**CAER Carbon Fiber Development**  
**Project # 2543.0**  
**ADDENDUM # 2**  
09/16/2024

## ADDENDUM NUMBER TWO

# UK CAER-CARBON FIBER DEVELOPMENT FACILITY

# ANITARY AND VENT RISER - ALT#1

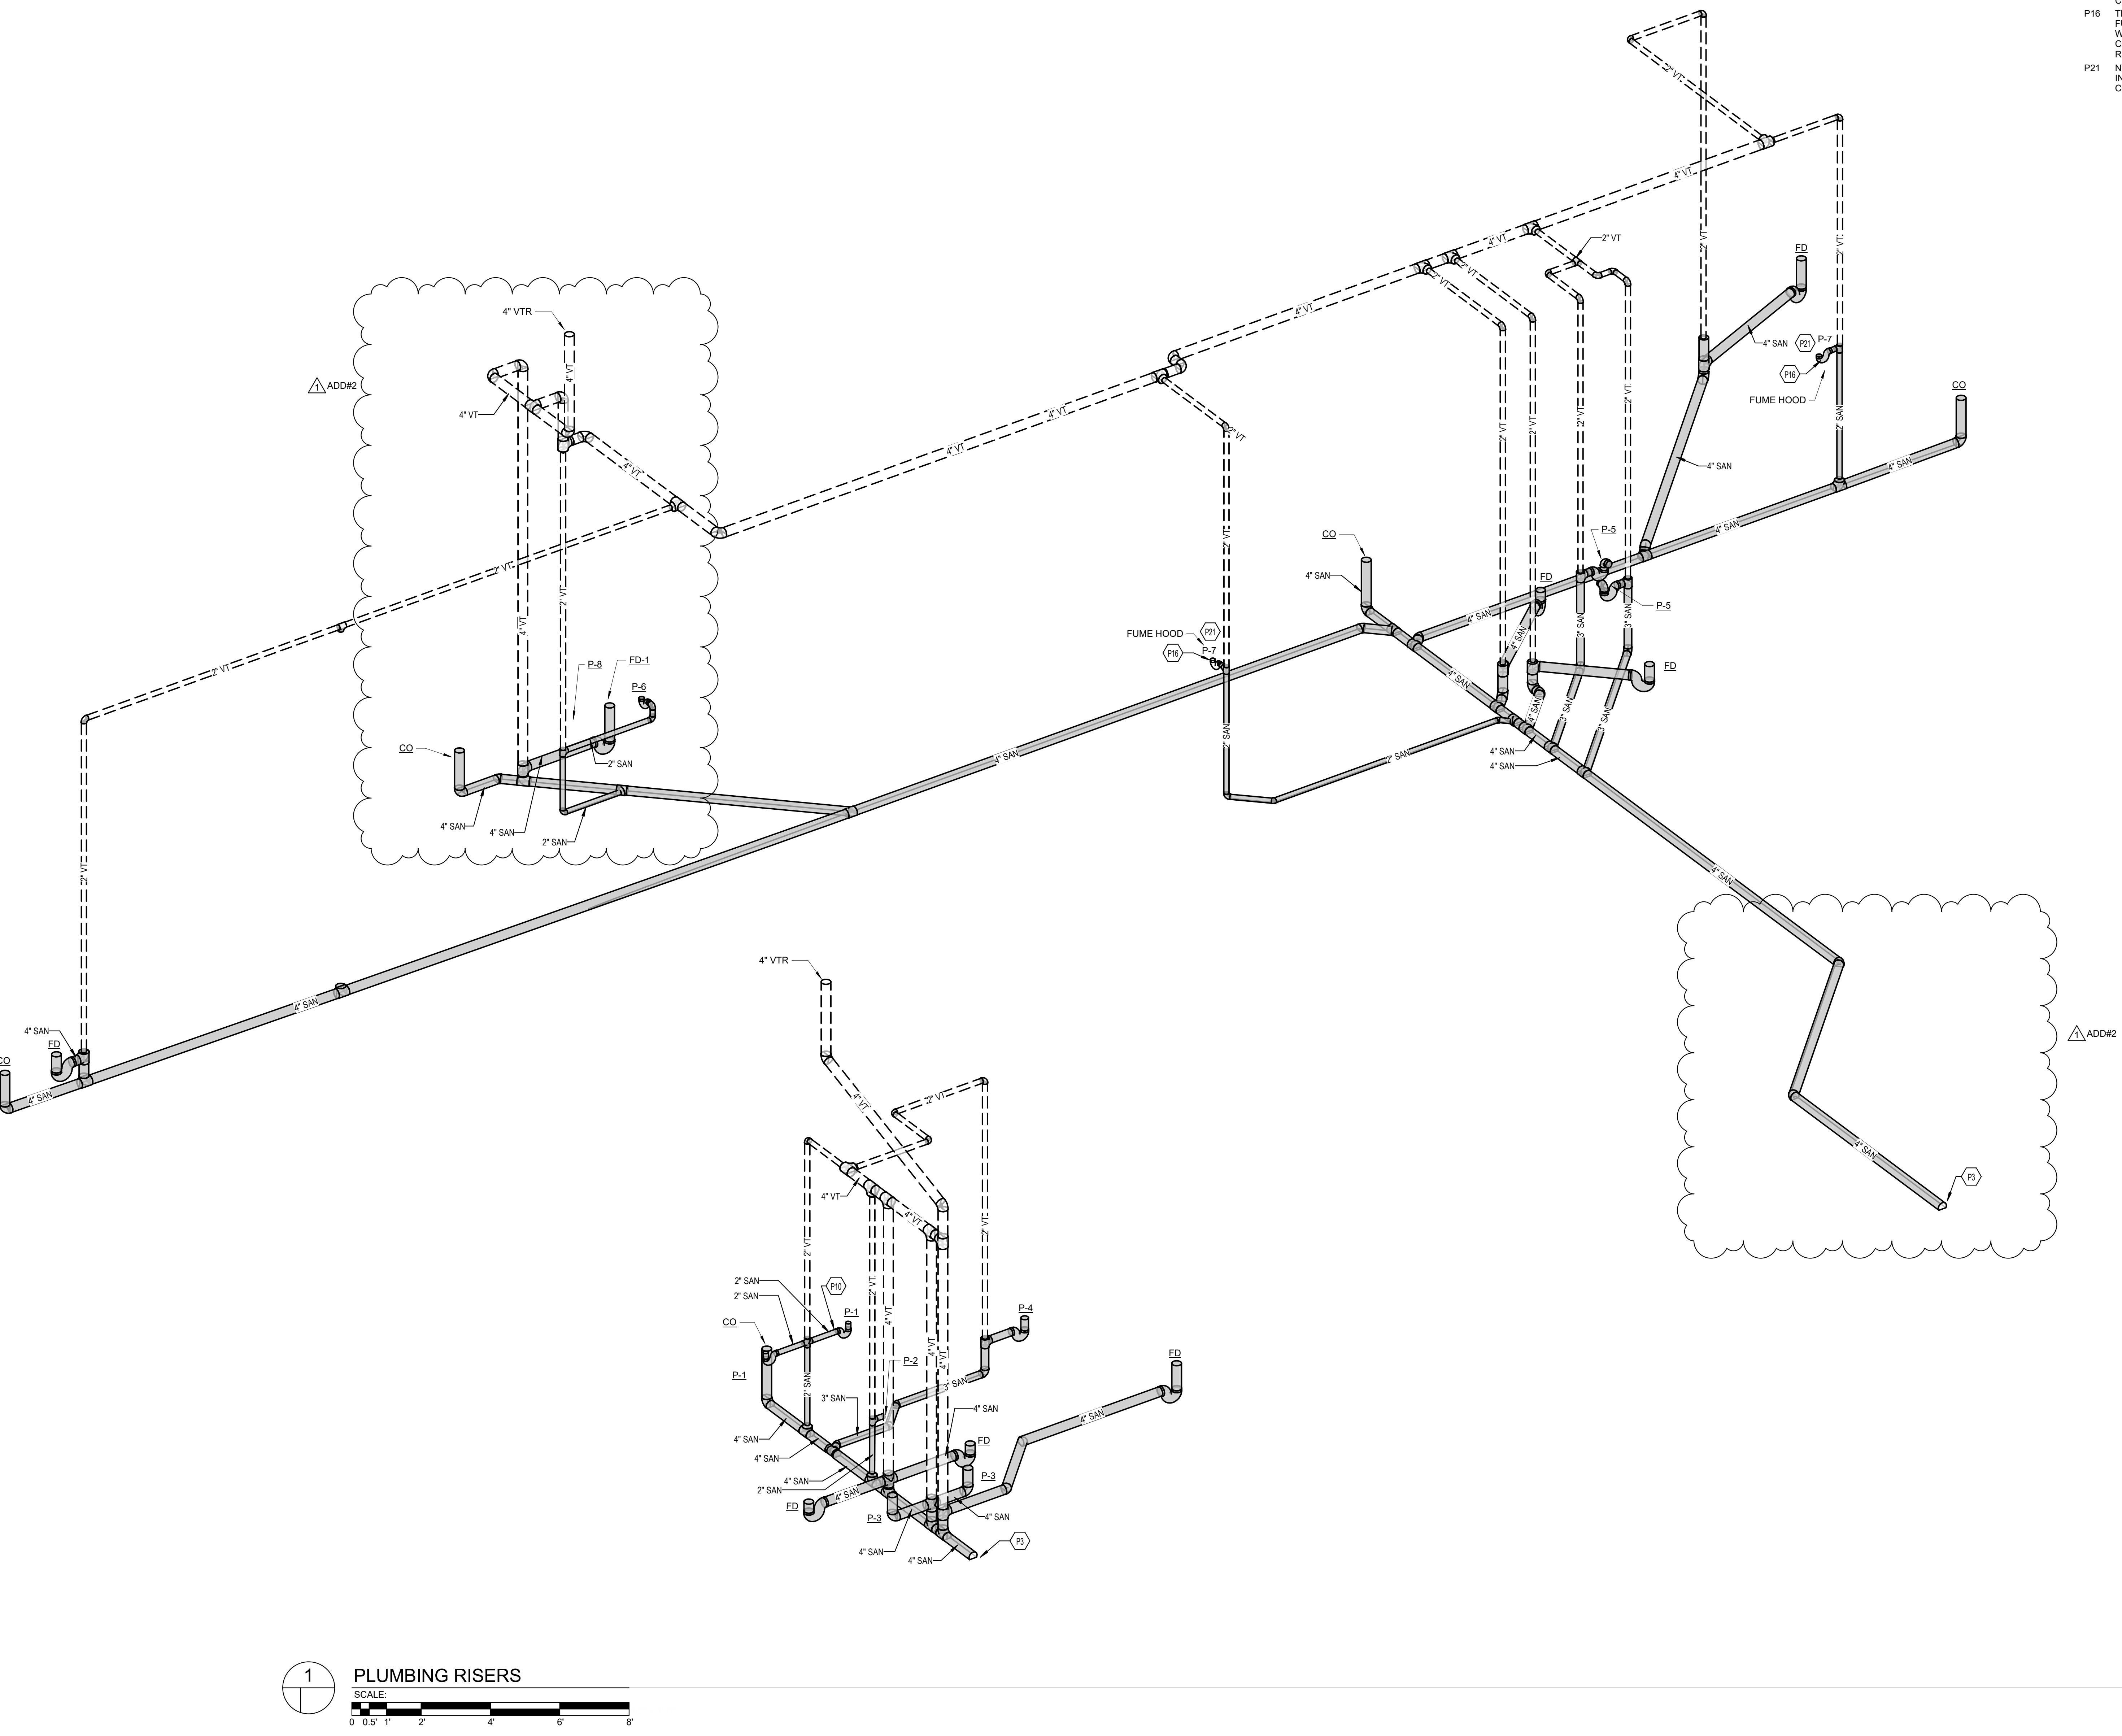
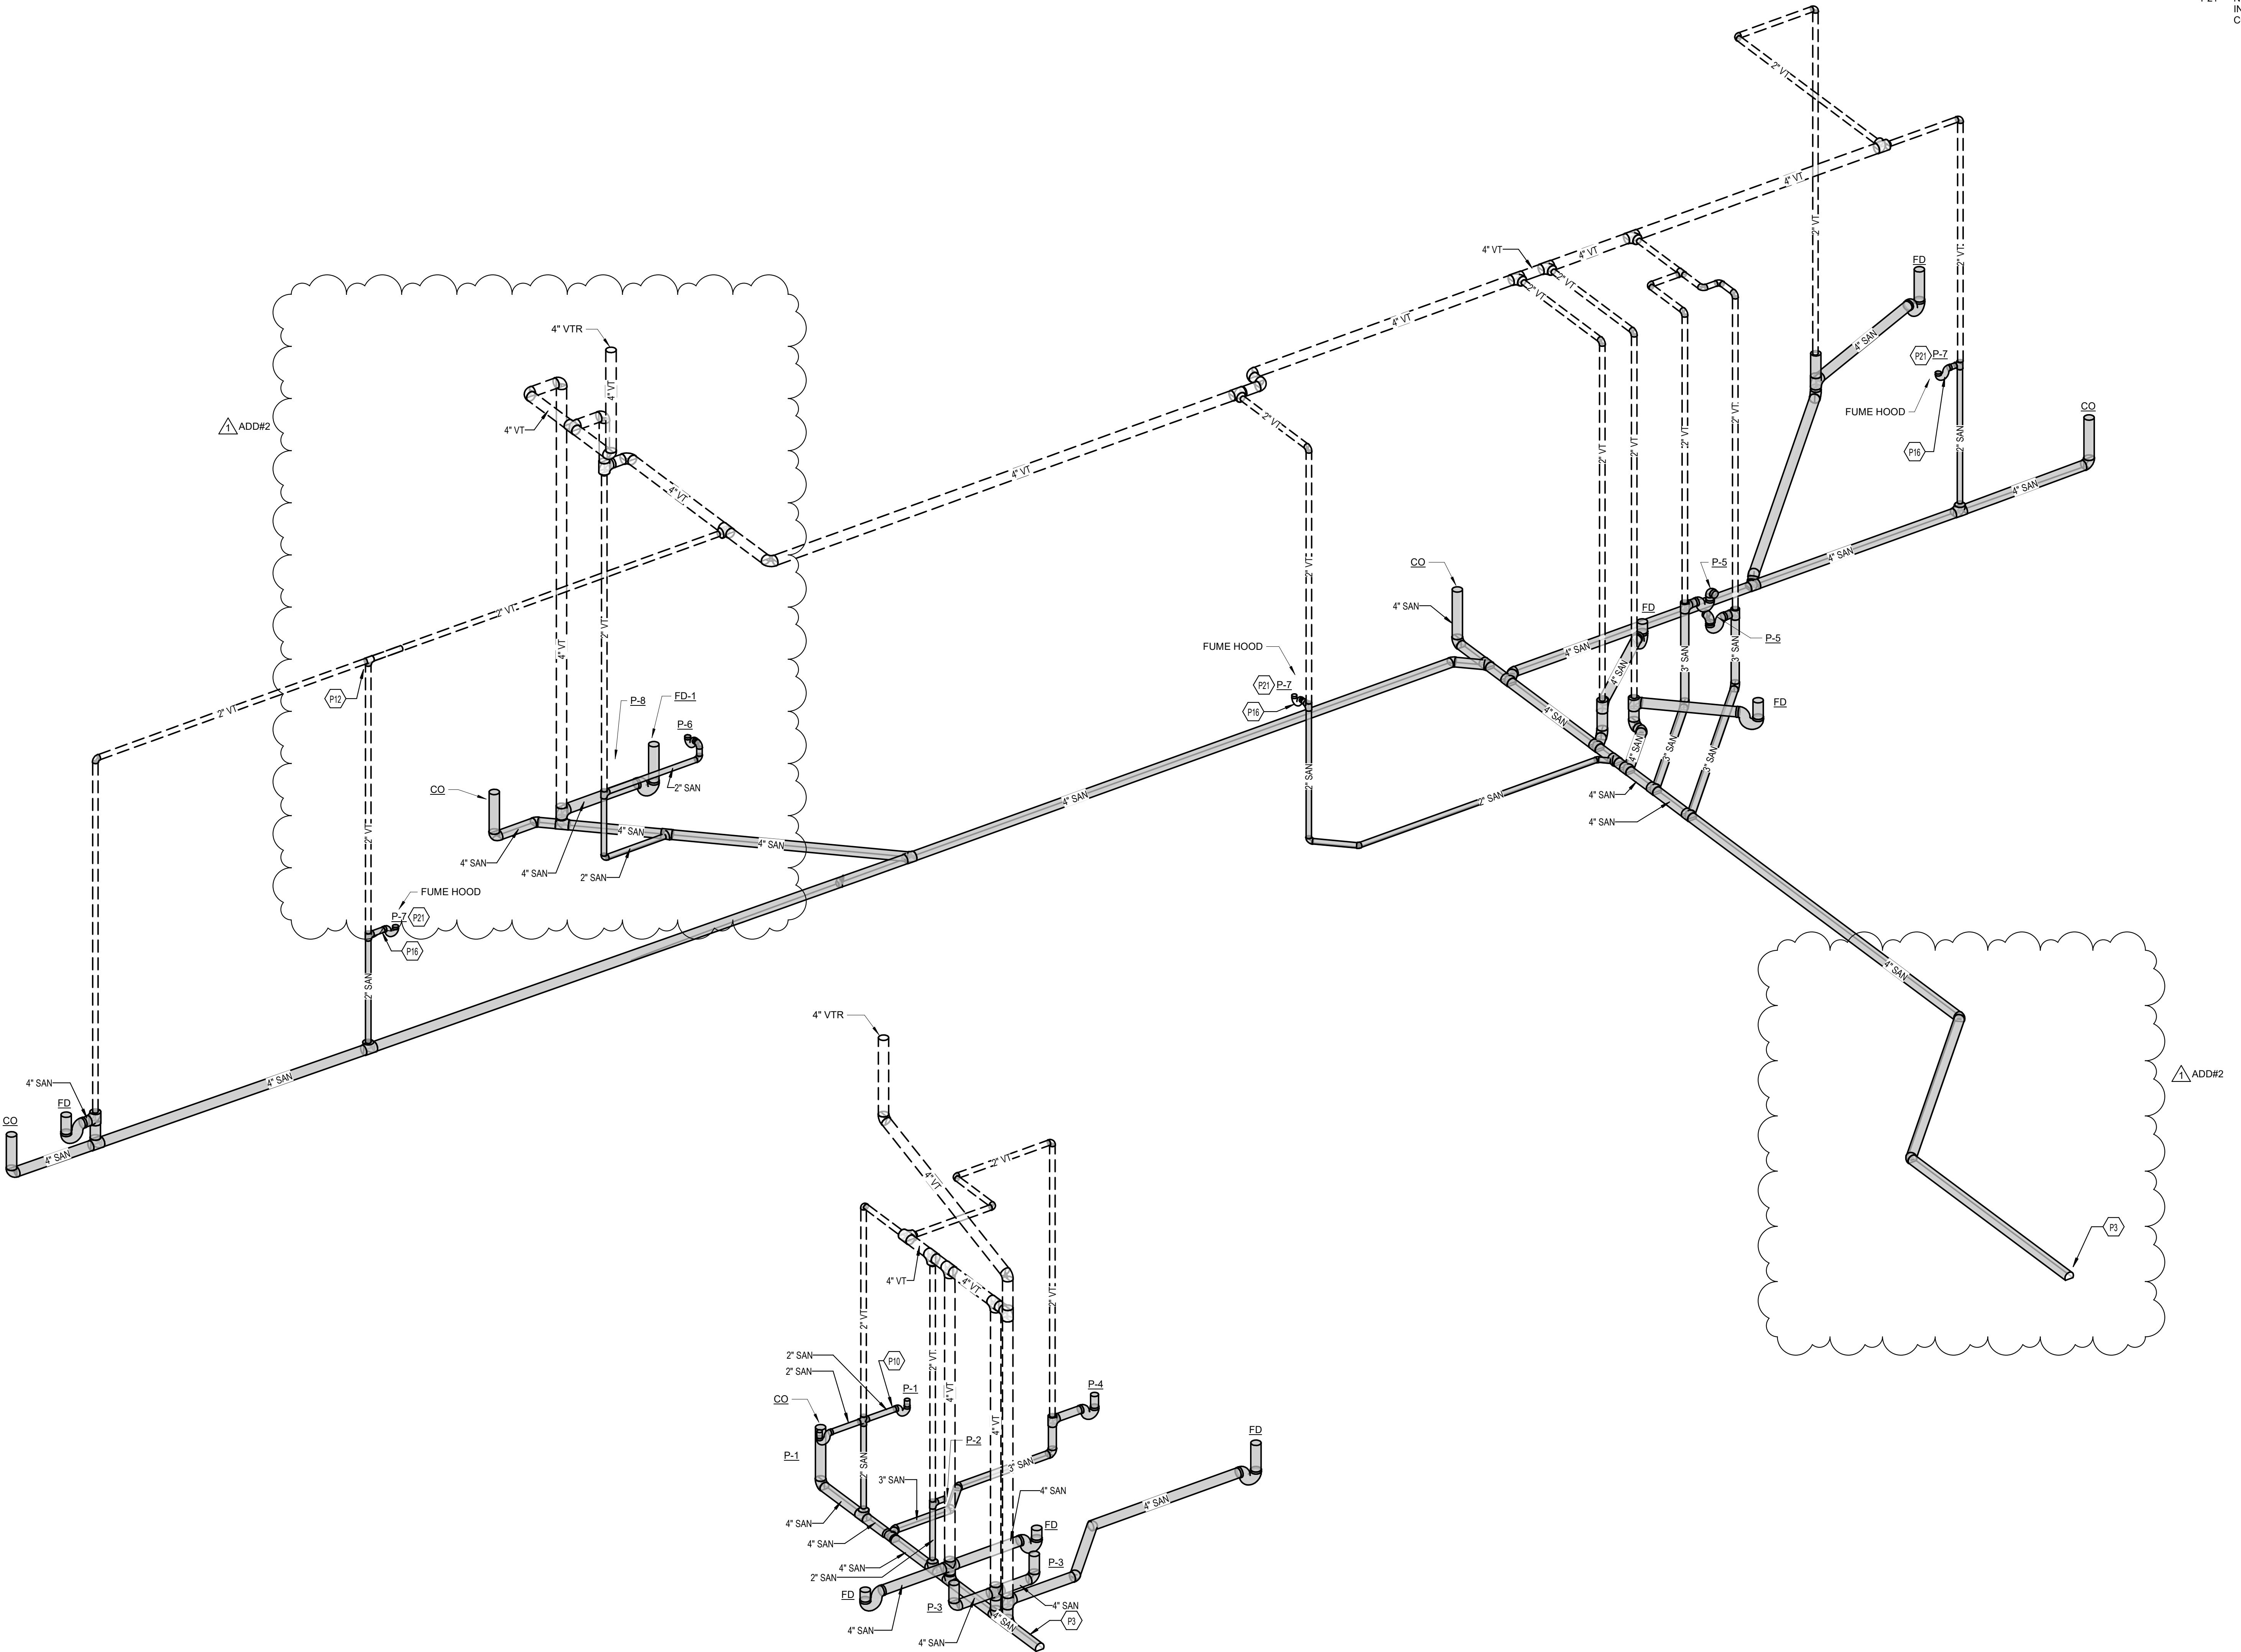
11. Refer to the Plumbing Drawings, Sheet P4.0A – SANITARY AND VENT RISER – ALT#1: Revised riser per the updates in this addendum. Refer to clouded revisions on sheet.
